## **BID ADDENDUM NO. 6**

### **Johnson Student Center**

### **Building Demolition, Increment 1 (Demolition) and Increment 2**

RANCHO SANTIAGO COMMUNITY COLLEGE DISTRICT  
SANTA ANA, CA

**SECTION 15/A6.12**

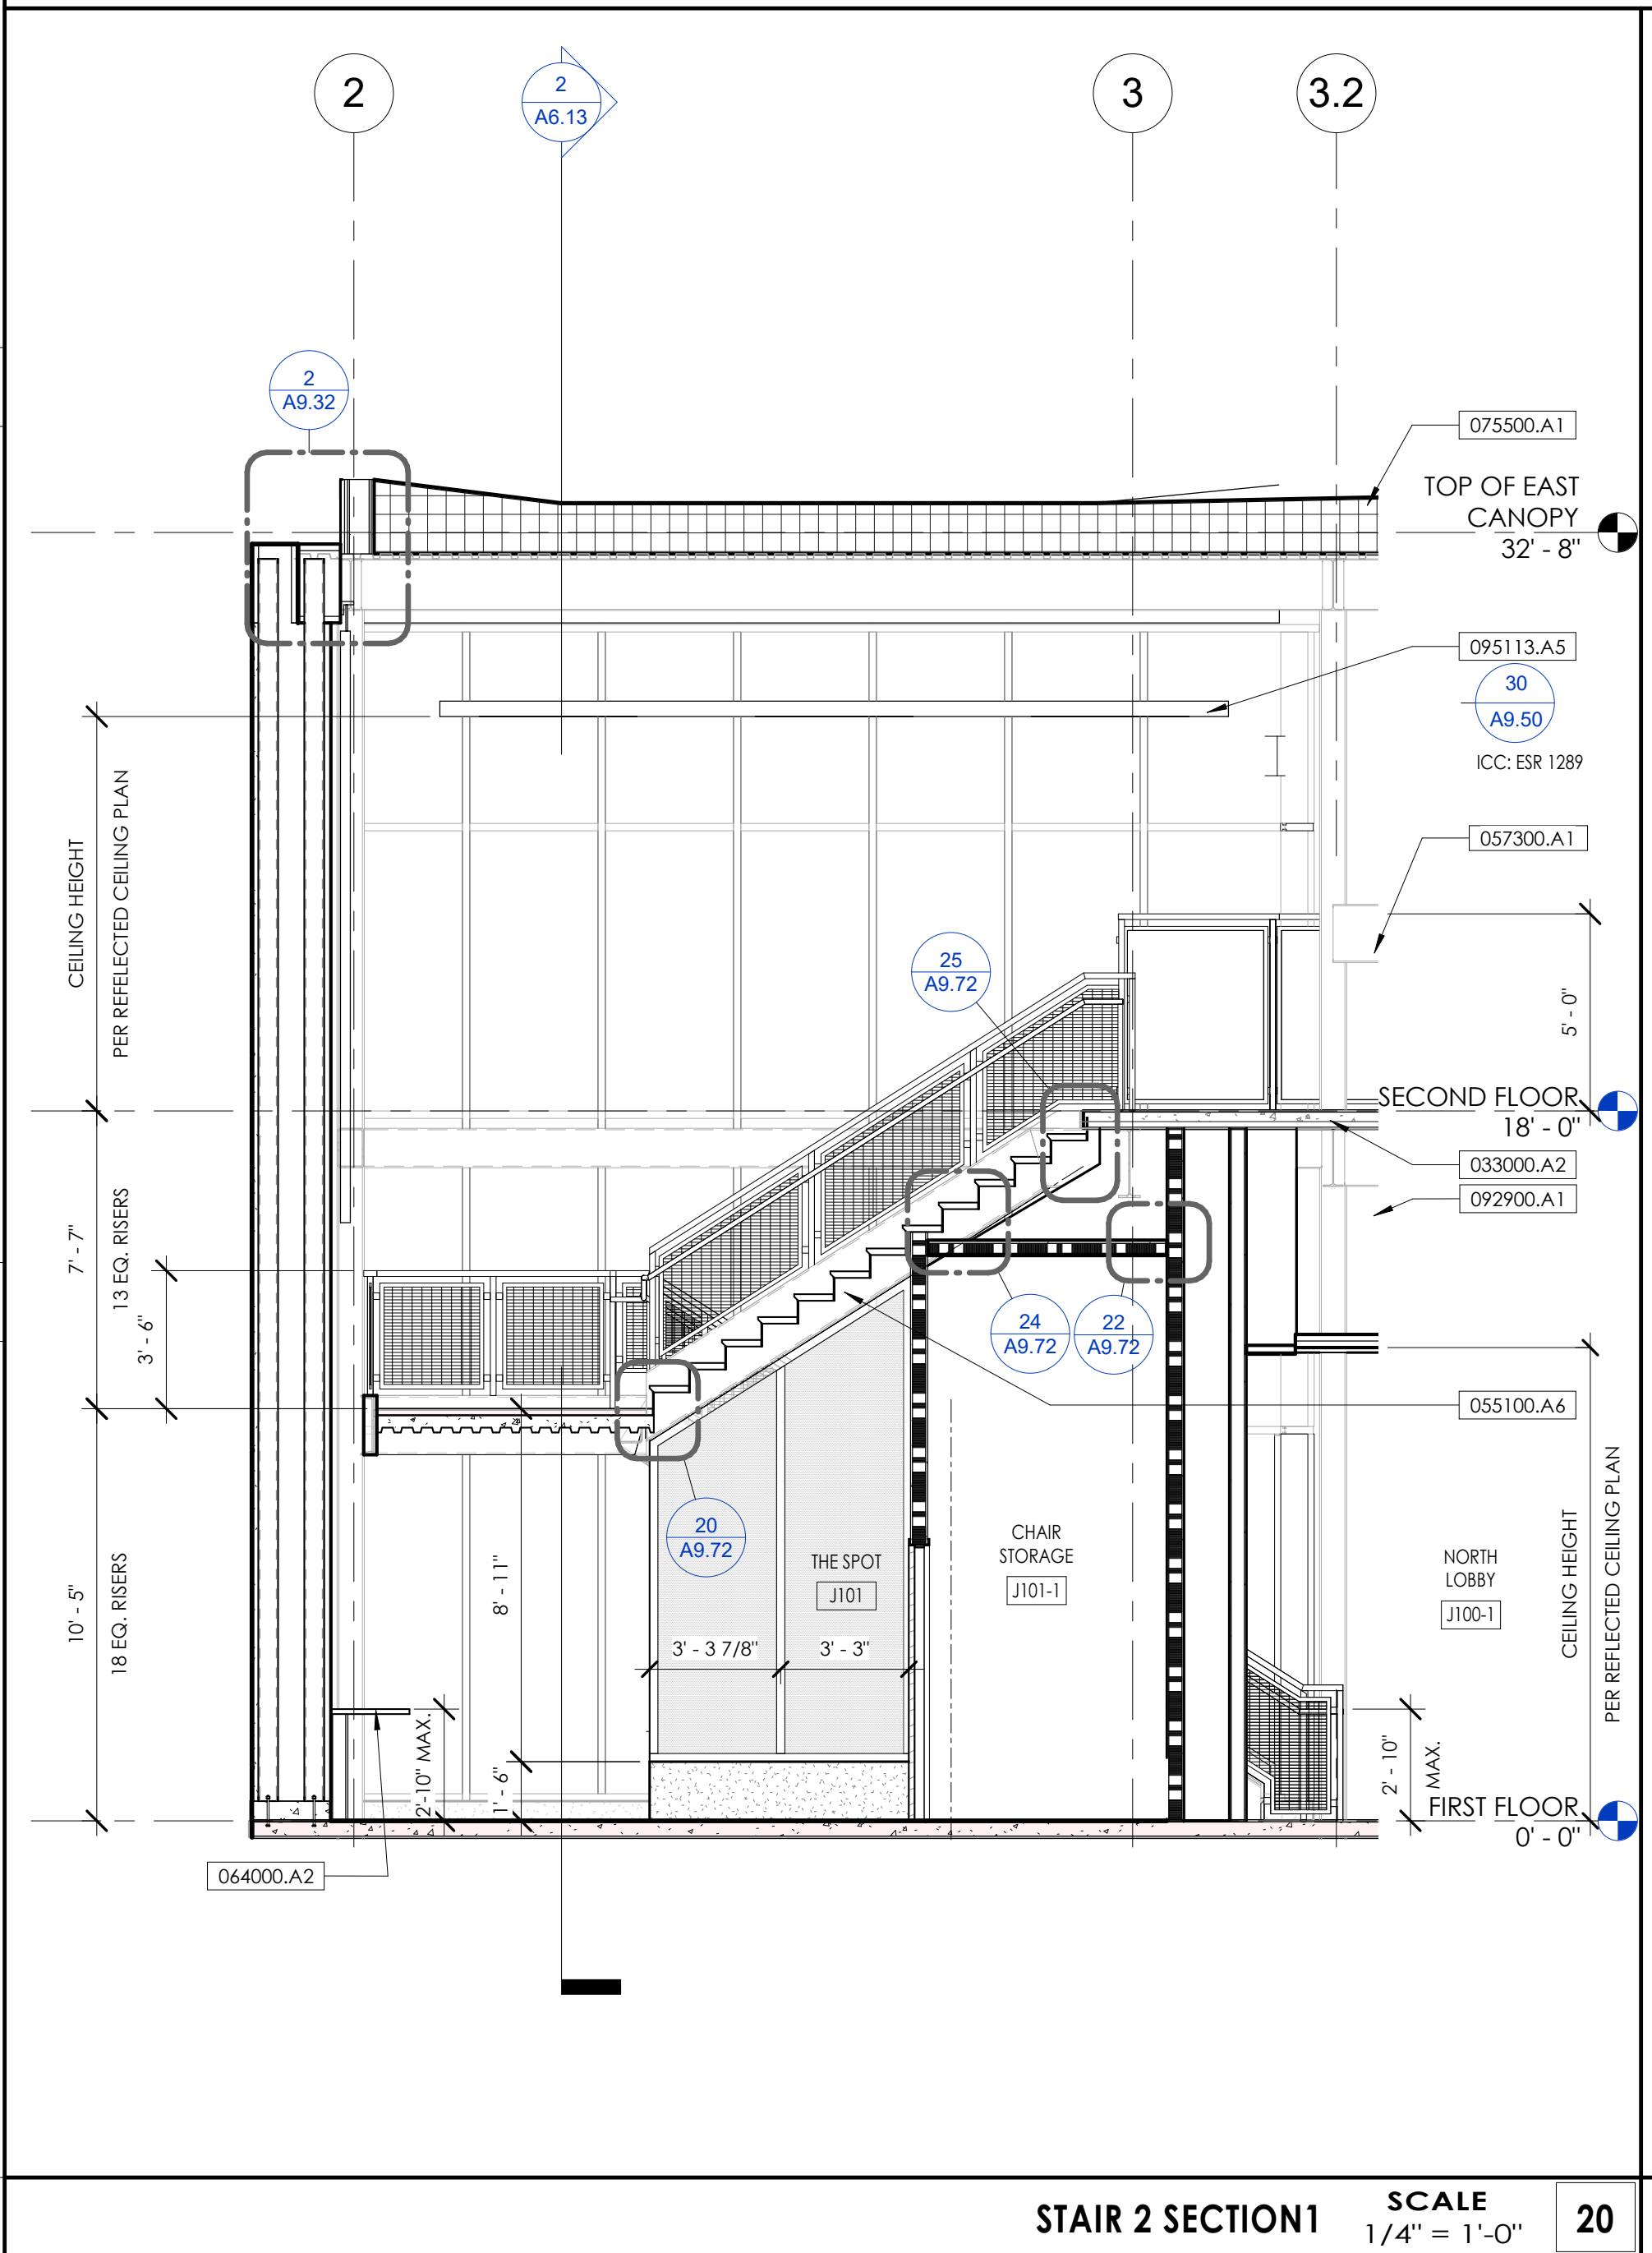
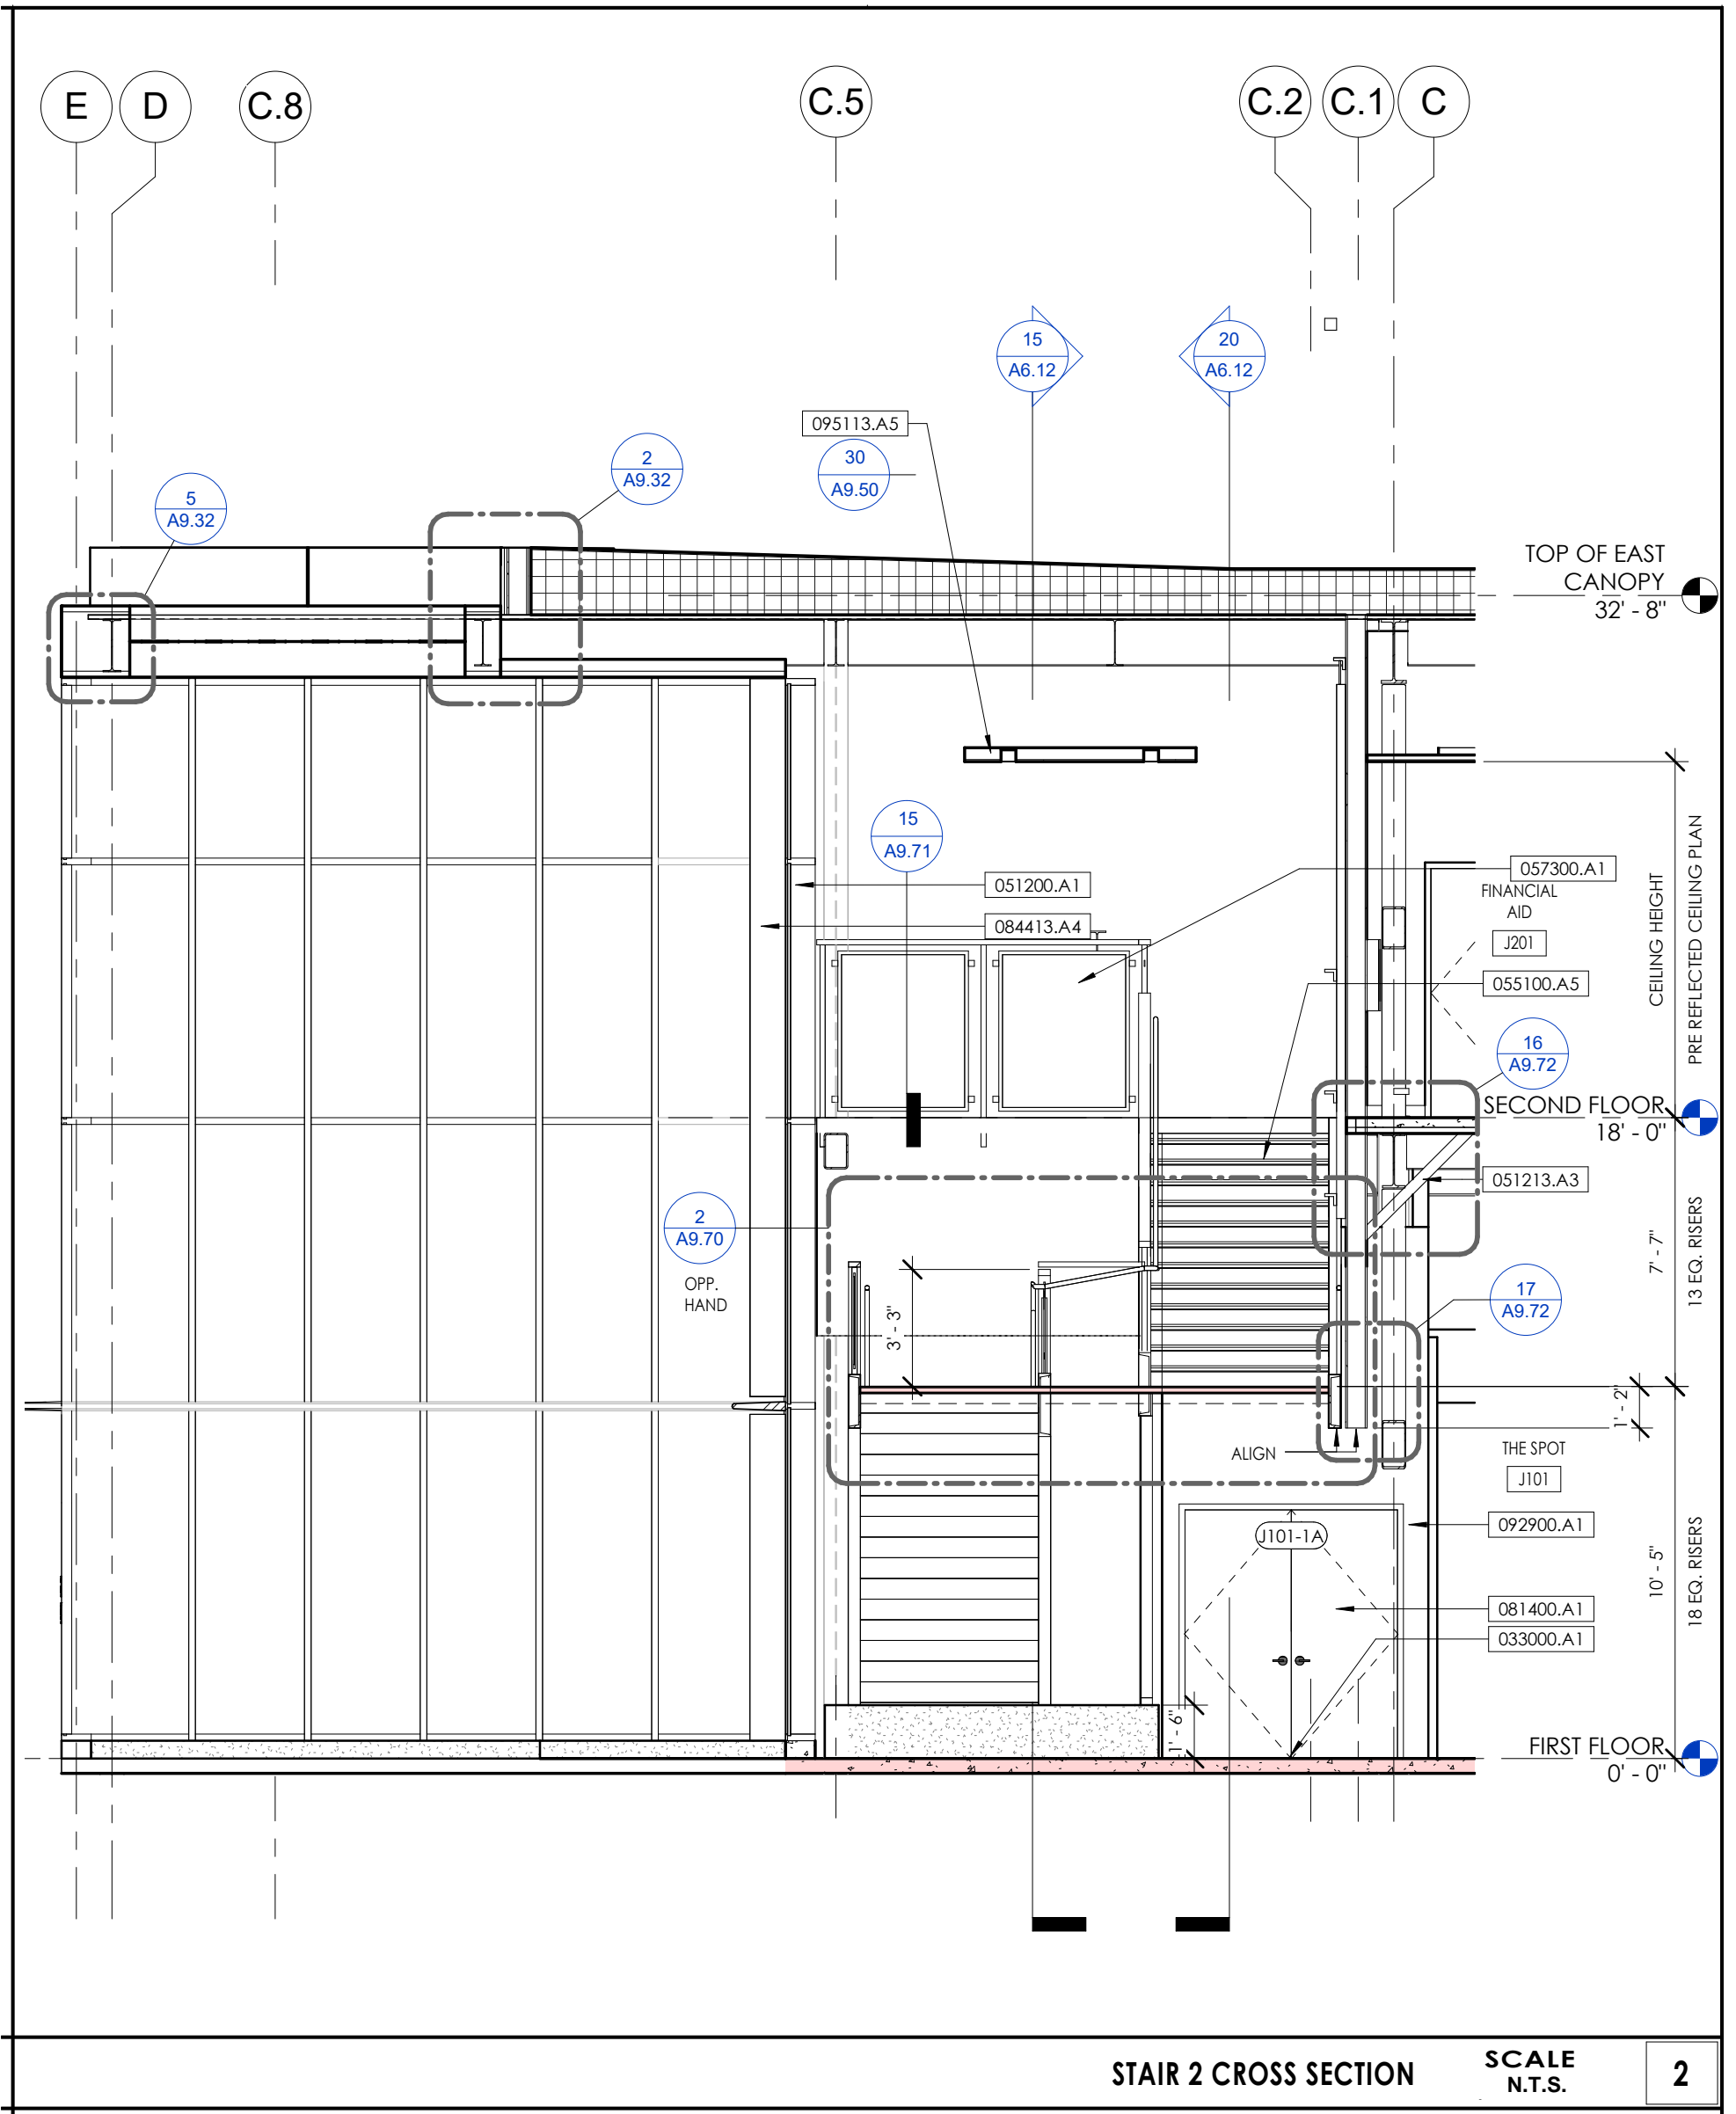
Increment #2 - Sheet A2.30, just north of Gridlines "2" between Gridlines "C" and "D" there appears to be a roof parapet at 32'-4 1/2", however 1/A5.02 takes you to 3/A5.11 which then takes you to 2/A9.32 and there are no details for this parapet. See attached for reference. Please review and advise.

FOR THE CANOPY WITH ROOF PARAPET, SEE ATTACHED REVISED DETAIL 2/A9.32. FOR THE CANOPY WITHOUT PARAPET SEE ATTACHED REVISED DETAILS 5/A9.32. FOR ALL OTHER DETAILS AND SECTIONS SEE ENLARGED ROOF PLAN 15/A6.12. ATTACHED DETAILS, SECTIONS AND PLANS ARE REVISED OTHERWISE USE THE DSA APPROVED SET. DIMENSIONS PROVIDED ON ENLARGED ROOF PLAN FOR MORE CLARIFICATION.
